City of Alexandria, Virginia

MEMORANDUM

SUBJECT: CONCEPT REVIEW OF 1A PRINCE STREET – WATERFRONT PARK AND
PUMP STATION AND LUMLEY PARK
BAR CASE # 2024-00435

Figure 5: Concept 1A (top) and Concept 1B (bottom) for the design of Waterfront Park

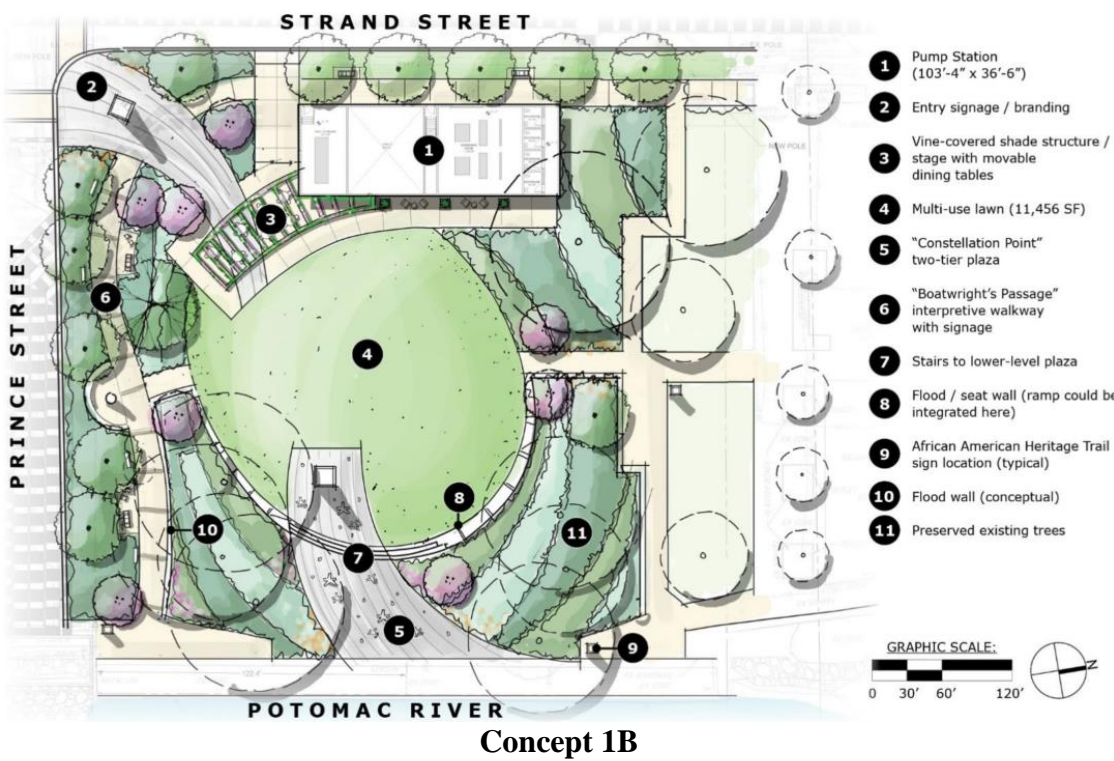
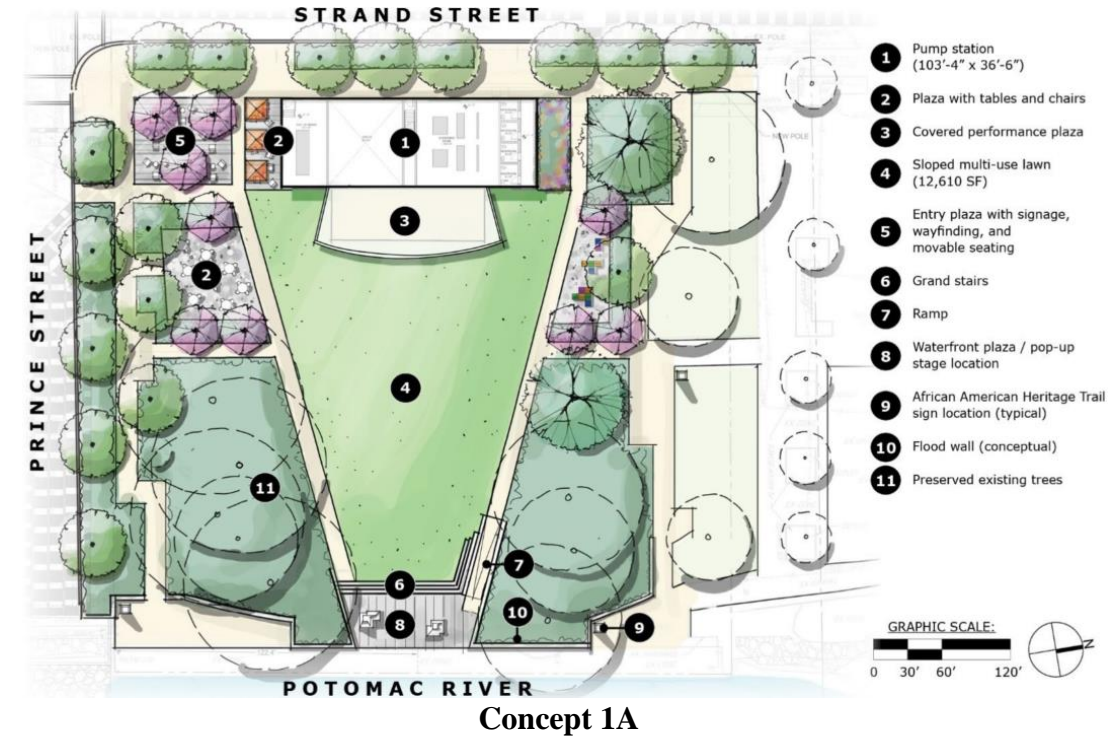
The City is proposing variations on the overall design concept for Waterfront Park based on the final location of the pump station. There are two different designs for the park with the pump station located on the western edge of the park, these are labeled Concept 1A and Concept 1B (Figure 5).

Figure 7: Option 1 for the design of the pump station

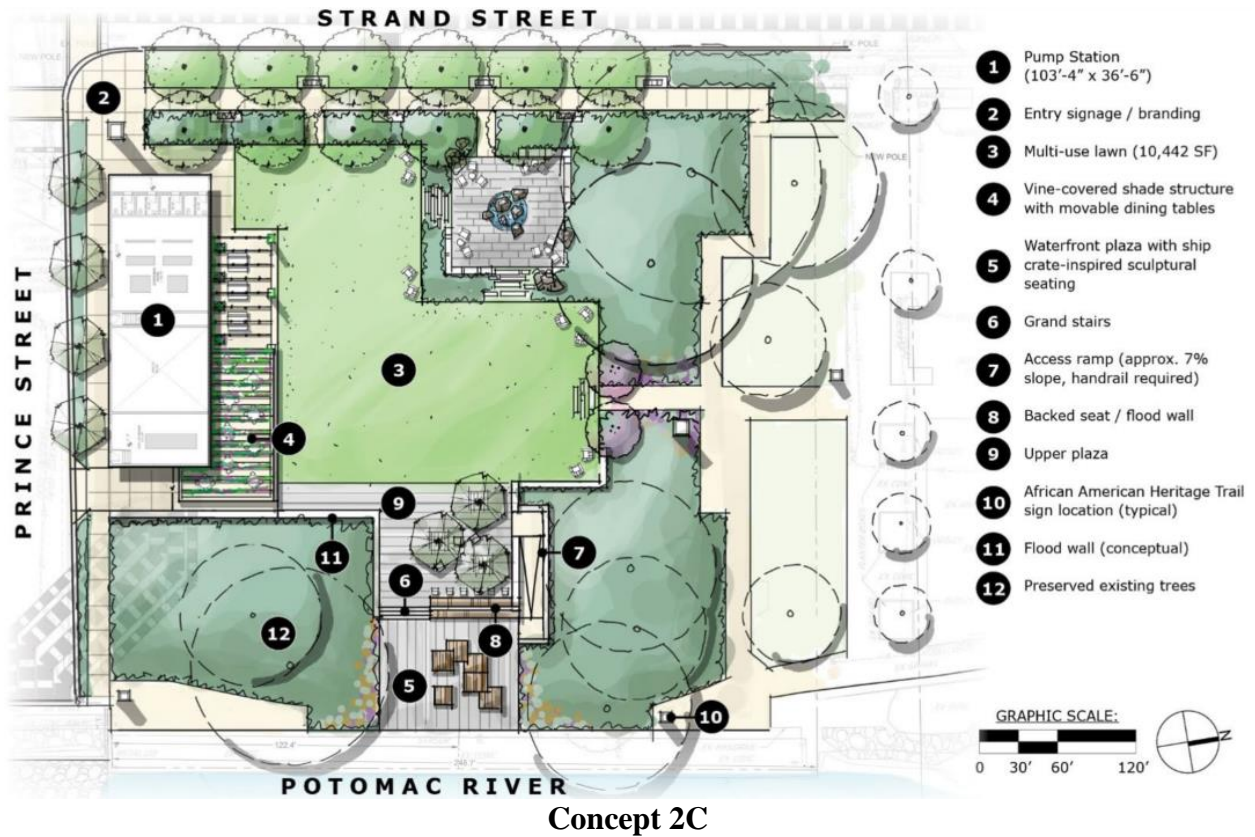
Option 1 uses an industrial design motif with a stone base and red brick above. The red brick is broken into vertical pilasters that stop at soldier courses at the top of the stone and at the coping. Square openings for “false windows” and louvers are located in each bay with these openings aligned with the pilaster on the long side of the building (Figure 7). This industrial motif is reminiscent of the warehouses and other industrial uses historically found at the project site, however the Board should note that these buildings are no longer in place, modern buildings now surround the park.

If the Board finds that this approach is most appropriate for the site, staff recommends that the City continue to develop and refine the architectural details. The pilasters should have greater relief from the building and be expressed at both the top and bottom of the structure. The second floor wall openings should be pulled away from the pilasters and they should all read the same, regardless of whether it is a louver or a “false window.” As with the second floor openings, the ground floor openings should be better composed with each of the bays. Larger openings should be aligned with the openings above and the floating second floor garage door opening should be grounded somehow. The brick walls are currently showing a soldier course at the top, the applicant should explore the use of a precast coping in this area to create a clear top to the building.
